NEWMAR CORP P.O. Box 30, Nappanee, IN. 46550 Title block--1TB	Model:	Sheet	Drawn by:	Checked by:	Revision: FIXED DIMENSIONS FOR SECTION A-A, B-B, AND VIEW "A"	By: D. K.
	(SEE INDEX)	1 OF 1	J. K.	D. K.		Date: 6/23/15
	Title: STRUCTURAL S-O FASCIA PLYWOOD & TRIM DETAILS	I.D. # 2016 HEAVY PARTS MISC9001	Date: 5/13/15	Date: 5/13/15	Revision: CREATED NEW PRINT TO SHOW NOTCH AT BOTTOM OF STRUCTURAL FASCIA	By: J. K.
					FOR HWH FLUSH FLOOR SLIDES (ECD #83)	Date: 5/13/15

NEWMAR CORP P.O. Box 30, Nappanee, IN. 46550 Title block--75TB	Model:	Sheet	Drawn by:	Checked by:	Revision: REVISED BASE BOARD COVER DESIGN, (PCR #161627)	By: S. W.
	DS DP (TYPICAL)	1 OF 1	D. K.	M. W.		Date: 6/22/15
	Title:	I.D. # 2016\BP\CAB\FASCIA\DSV\OSDP_FASCIA_HWH	Date:	Date:	Revision: ADDED NOTCH TO BOTTOM OF LOWER FACIA, ADDED BASE BOARD COVER	By: S. W.
	HWH FASCIA		1/27/15	1/27/15		Date: 5/28/15

FOOT BLOCK CAP DETAIL
SECTION E-E
SCALE: X2

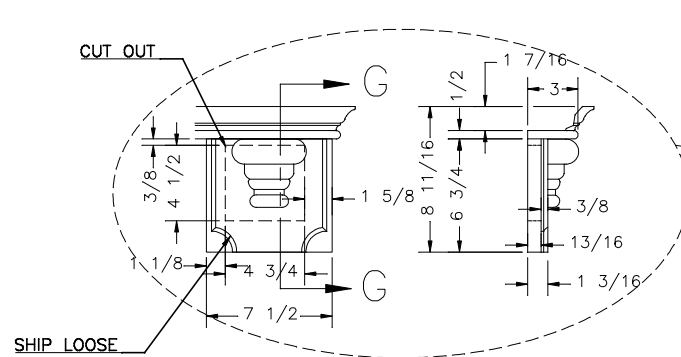
NEWMAR CORP P.O. Box 30, Nappanee, IN. 46550 Title block--75TB	Model: DS DP (TYPICAL)	Sheet 1 OF 1	Drawn by: D. K.	Checked by: M. W.	Revision: CORRECTED WIDTH OF SECTION E-E AND LOCATION OF CROSS SECTION. ADDED VIEW F-F FOR WIRE NOTCHES AND RENAMED SECTION E-E IN "CAP BLOCK" DETAIL TO G-G (PCR #141237)	By: D. K. Date: 4/16/13
	Title: FASCIA	I.D. # 2014\DP\CAB\FASCIA\DS\DS DP_FASCIA	Date: 10/11/12	Date: 11/30/12	Revision: REVISED FASCIA FOOT BLOCKS.	By: A. M. Date: 3/20/13

FOOT BLOCK CAP DETAIL
SCALE: X2

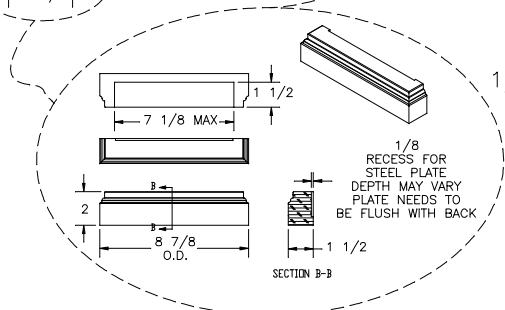
ADDED CUT OUT FOR CORNER BLOCK, NOTE TO SHIP LOOSE, REVISED
THICKNESS OF FOOT BLOCK (PCR #141158)
ADDED DETAIL FOR FOOT BLOCK CAP

TOOL ACCESS BASE BOARD COVER DETAIL
(REMOVABLE - ATTACHED WITH MAGNETS)
SCALE: X2

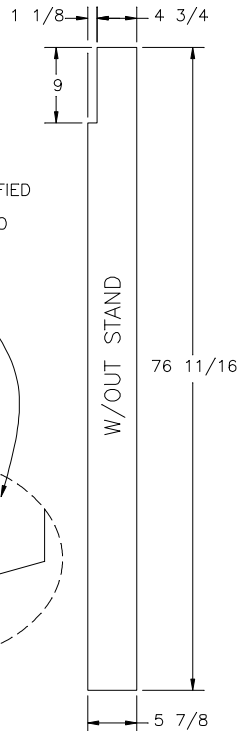
ALL OF THESE PARTS, RETURN, CLEATS & BASE BOARD COVER SHOULD BE BUILT 1/4" OVER SPECIFIED HEIGHT BY VENDOR. THESE PARTS WILL BE TRIMMED TO SIZE AT NEWMAR BEFORE INSTALLATION.

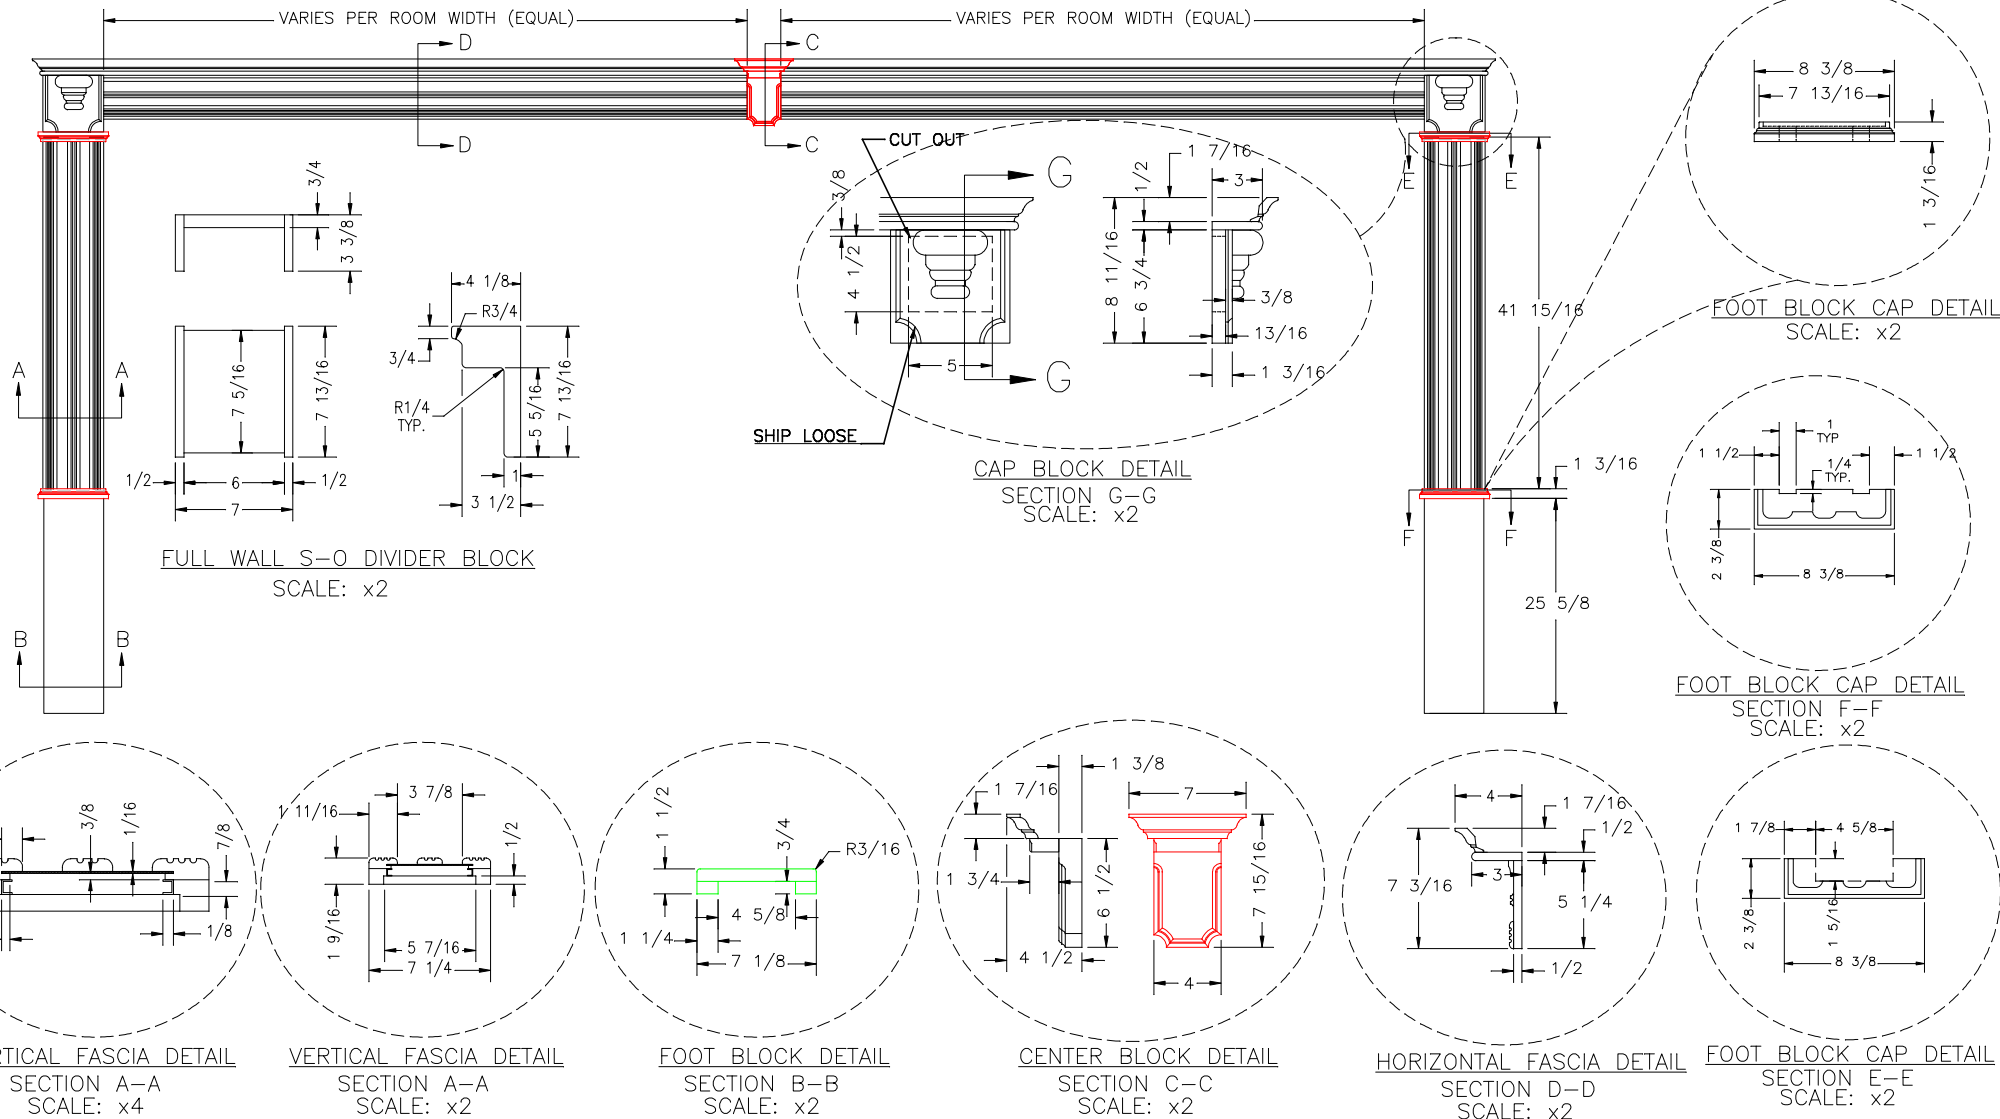
CHANGED DRAWING BACK TO ORIGINAL BEFORE PCR # 167076 & MOVED	T. S.
CHANGES TO OTHER DRAWINGS (PCR #167076)	4/1/15
ADDED NOTCH TO FASCIA RETURN FOR THE END TABLE. ADDED SECOND	T. S.
VIEW TO DICTATE & OPTIONAL DIFFERENCES (PCR #167076)	3/23/15
REVISED THE FOOT BLOCK DETAIL TO BE 8 7/8" WIDE ILO 8 3/8"	A. M.
